To: ATA Committee
From: Mehran Ramezani
Ernulex Corporation
(714)668 5331 Tel
(714)668 6654 Fax
July 20, 1992
Subject: DMA Timing Changes in ATA Document

I would like to propose the following changes to the "AT Attachment Interface Document, Figure 11-3: DMA DATA TRANSFER":

FIGURE 11-3: DMA DATA TRANSFER

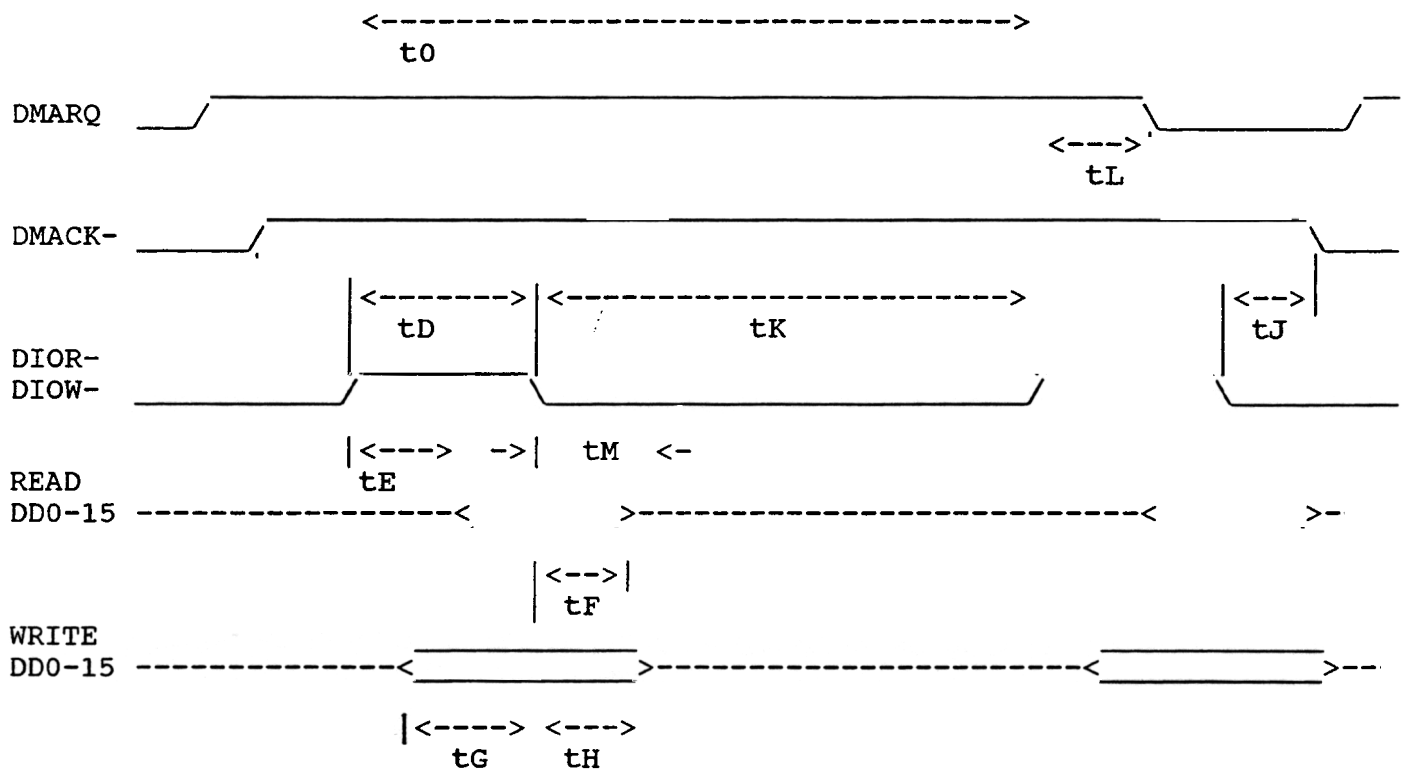
A) The definition for "tE" is changed from "Data Setup (Min)" to "Data Access (Max)".

B) The modes 0, 1 and 2 are defined for single transfer DMA cycles. If these modes are to be preserved, there would be a need to create a fourth mode (Mode 3), to accommodate the timing requirements of EISA DMA Type "B", Demand Mode.

Note: It may be possible, by modifying some of the timing parameters of either mode 1 or mode 2, to accommodate the needs of EISA Type "B" DMA. And then create a new feature in SET FEATURES Command, to handle Multiple Transfers (Demand Mode) vs. Single transfer DMA.

DMA Timing Parameters		Mode 0 nsec	Mode 1 nsec	Mode 2 nsec	Mode 3 nsec
t0	Cycle Time (Min)	960	480	240	480
tC	DMACK to DMREQ Delay (Max)	200	100	80	---
tD	DIOR-/DIOW- 16-bit (Min)	480	240	120	215
tE	DIOR- Data Access (Max)	250	150	50	150
tF	DIOR- Data Hold (Min)	5	5	5	5
tG	DIOW- Data Setup (Min)	250	100	35	100
tH	DIOW- Data Hold (Min)	50	30	20	20
tI	DMACK to DIOR-/DIOW- Setup (Min)	0	0	0	0
tJ	DIOR-/DIOW- to DMACK Hold (Min)	0	0	0	0
tKr	DIOR- Negated Pulse Width (Min)	---	---	---	50
tKw	DIOW- Negated Pulse Width (Min)	---	---	---	215
tLr	DIOR- to DMREQ Delay (Max)	---	---	---	120
tLw	DIOW- to DMREQ Delay (Max)	---	---	---	40
tM	DIOR- to Data Float (Max)	-	-	-	20
